Groundwater Application Review Summary Form

Application # G- 19450

PUBLIC INTEREST REVIEW FOR GROUNDWATER APPLICATIONS

A. GENERAL INFORMATION: Applicant's Name: Legacy Valley Farms, Inc. County: LINN

Water-Level Measurements in Nearby Wells

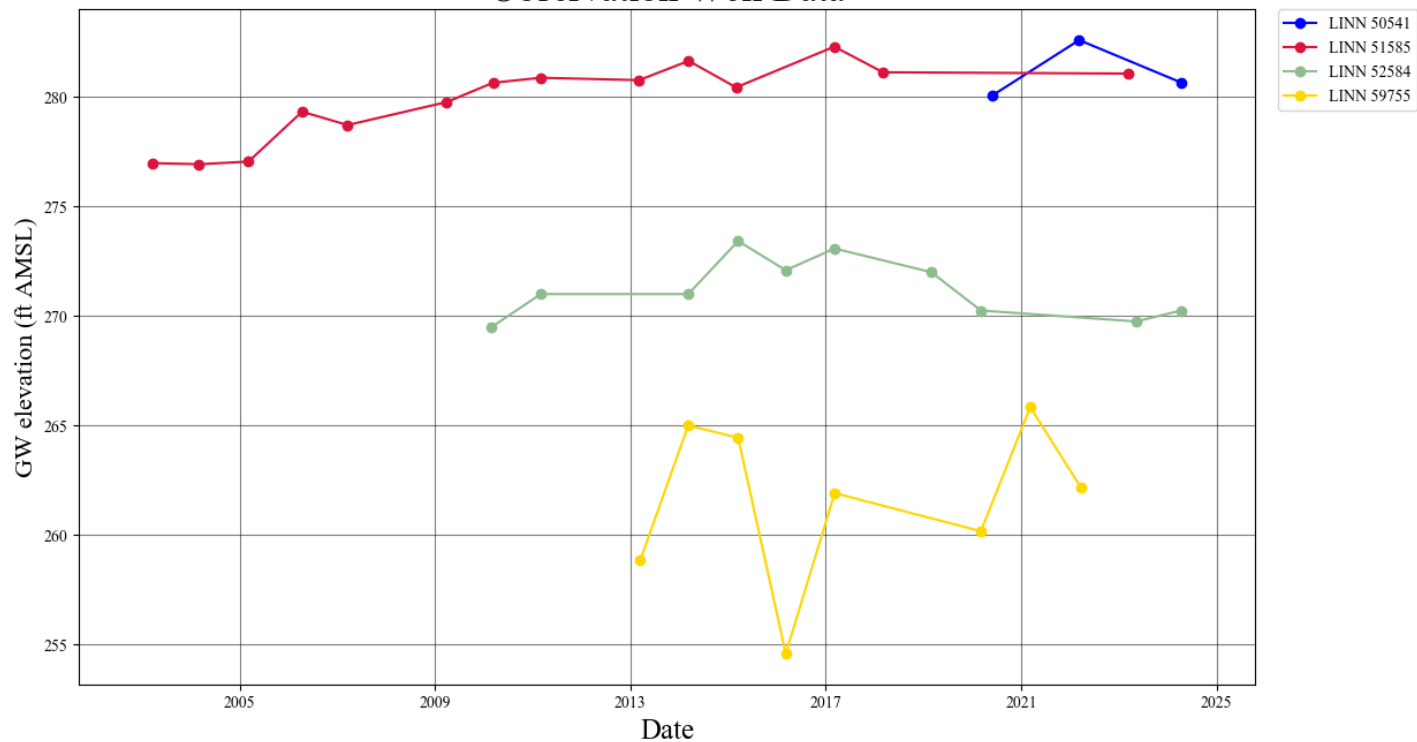
Water level measurements in nearby wells are generally stable (see attached Hydrograph). Based on these measurements and the hydrogeological conceptual model of the aquifer, the groundwater resource is not over-appropriated.

Well Statistics

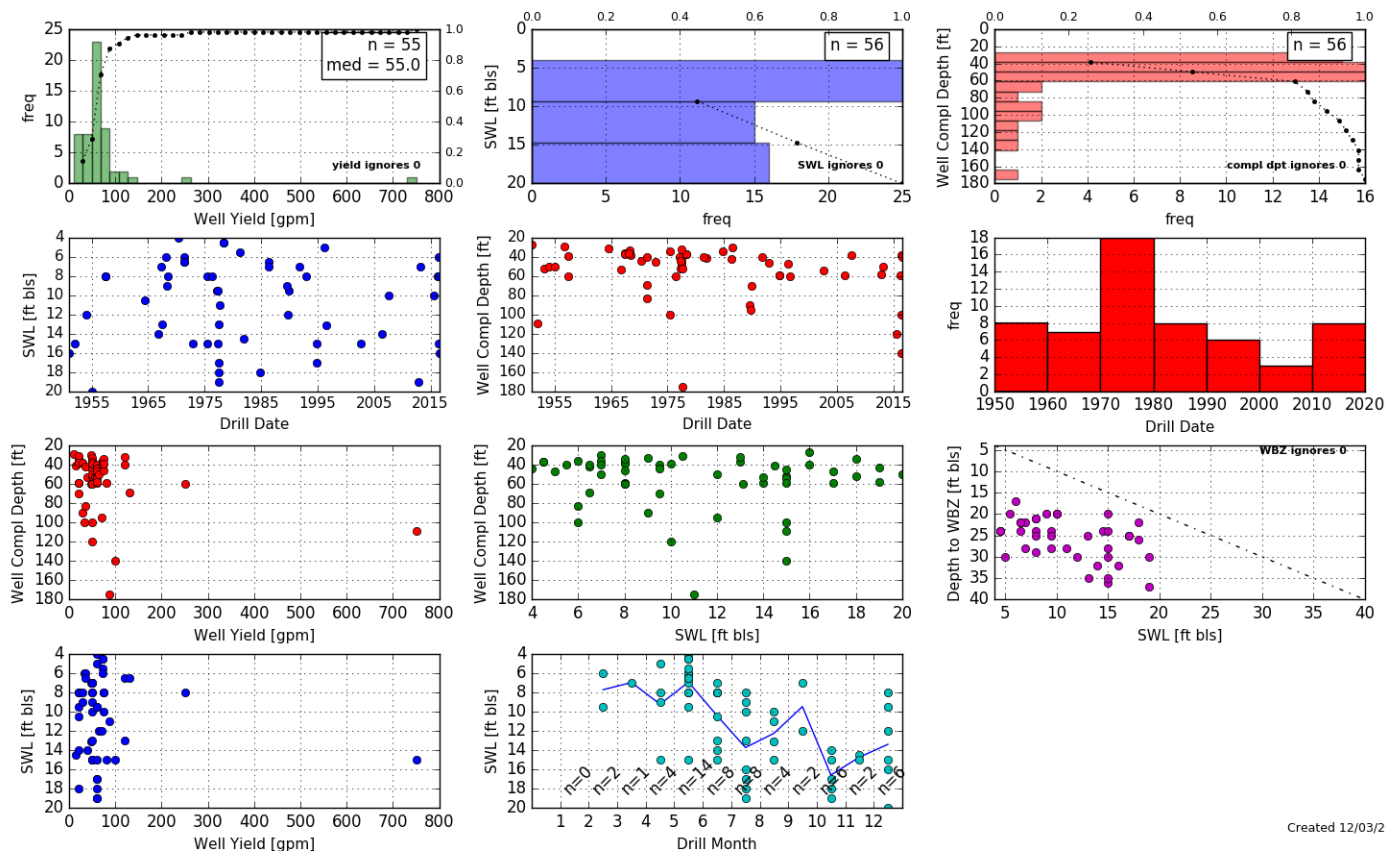
Reported yields in nearby wells range from 10-750 gpm (~0.02-1.67 cfs), with a median yield of 55 gpm (~0.12 cfs) (see attached Well Statistics). Applicant has requested well-specific rates for the proposed POA, with the highest being ~444 gpm (0.99 cfs) for proposed Well 3, which would be ~59% of the highest reported yield for any well in the area and ~807% of the median reported yield. **Based on the available data, the requested well-specific rate of 0.99 cfs for Well 3 is likely achievable and, therefore, within the capacity of the groundwater resource.** The next highest requested well-specific rate is for proposed Well 2 of 0.37 cfs (~166 gpm); 0.37 cfs is ~22% of the highest reported yield for any well in the area and ~302% of the median reported yield. The well specific rate for Well 4 is 0.26 cfs (117 gpm), which is 16% of the highest reported well yield and 213% of the median. **Therefore, the requested rates for proposed Wells 2 and 4 are within the capacity of the groundwater resource.**

Well 3 to LINN 13793

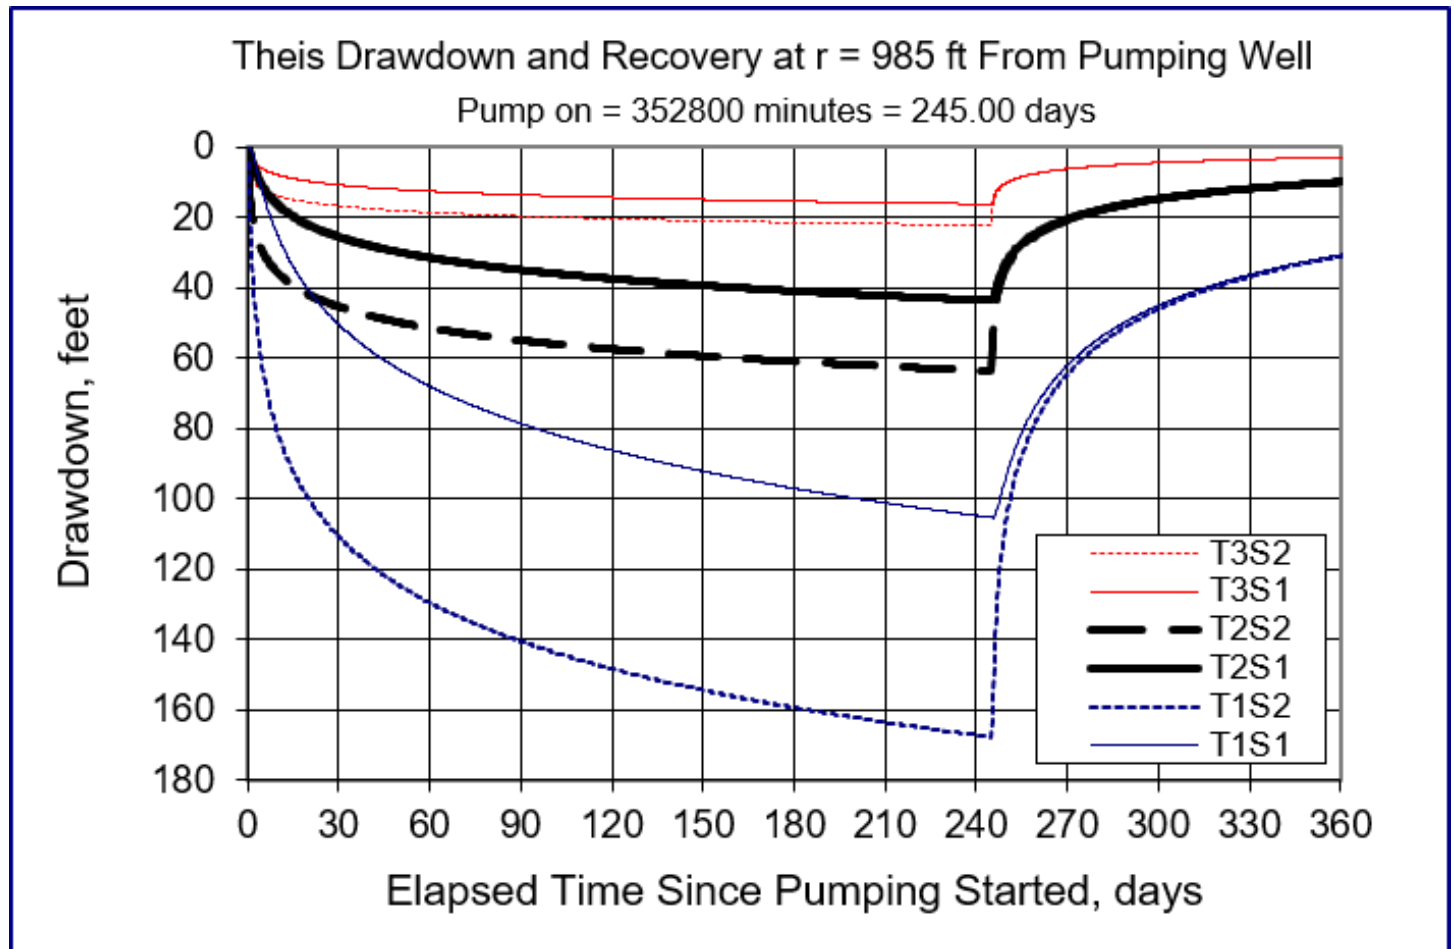
The nearest wells to the proposed POA are: LINN 13793, a domestic well, ~985 ft southwest of proposed Well 3; LINN 13815, a domestic well correlated to Tax Lot 800, ~1,200 ft northwest of proposed Well 4; and LINN 13779, an irrigation well, ~2,100 ft northwest of proposed Well 2. Potential interference with neighboring wells due to the proposed use was analyzed using the Theis (1935) solution for drawdown in a confined aquifer (see attached Well-to-Well Interference Analyses). **Results of the analyses indicate that, at a rate of 0.99 cfs, Well 3 is very likely to exceed 25 ft of interference with neighboring LINN 13793 within several weeks of pumping, which would then require curtailment under the standard**

permit conditions for new alluvial groundwater rights. **As such, the proposed use of Well 3 is not within the capacity of the resource. Furthermore, at a rate of 0.99 cfs, proposed Well 3 would likely cause injury to LINN 13793 before the end of the irrigation season.** Pumping by Well 2 and Well 4 is not anticipated to cause injury and is within the capacity of the resource.

For any permit issued pursuant to this application, the conditions specified in B1(d)(i) and B2(c) are strongly recommended to protect senior users and the groundwater resource.
